P 525697

TAX ID #  
**ON-SITE SEWAGE DISPOSAL SYSTEM**  
**HOWARD COUNTY HEALTH DEPARTMENT**  
**BUREAU OF ENVIRONMENTAL HEALTH**

Vinyl Remodeling IS PERMITTED TO INSTALL  ALTER

ADDRESS: 16015 Frederick Rd PROPERTY OWNER: Janice Compton

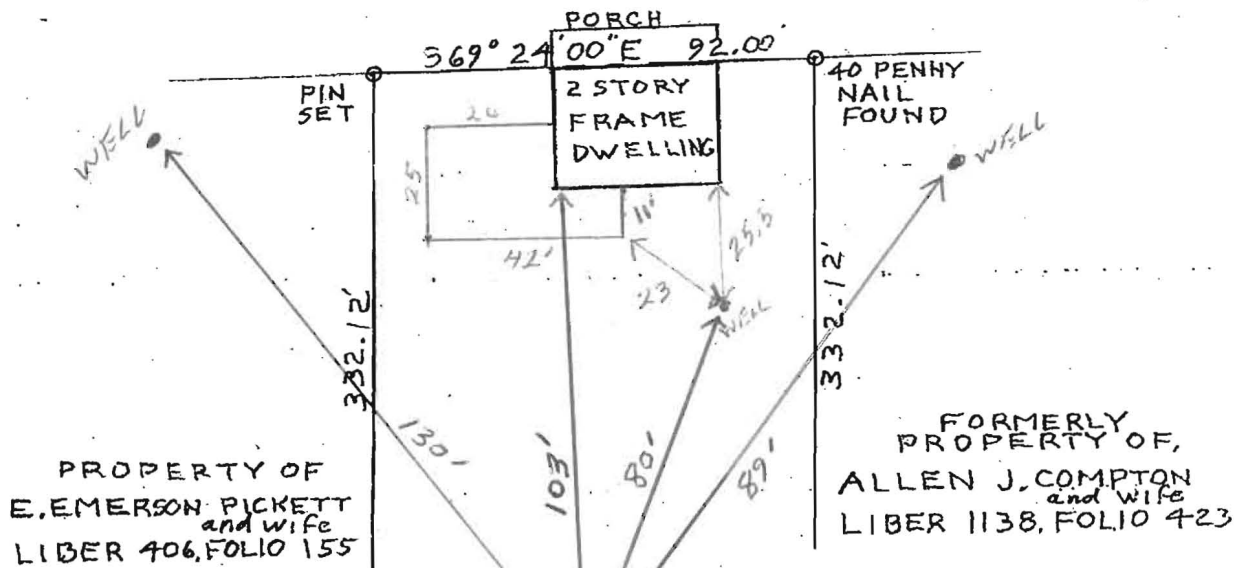
PRE-CONSTRUCTION 1/9/07 O.K. to install two 70'-75' trenches on contour with an inlet of 4' and a bottom of 8' if they are installed at or above the same elevation as new test hole (E) (BB)

INSTALLATION 1/10/07 Trenches finished. Need manhole cleanout on tank and speed levelers (BB)

1/11/07 Manhole cleanout and levelers installed. (BB)
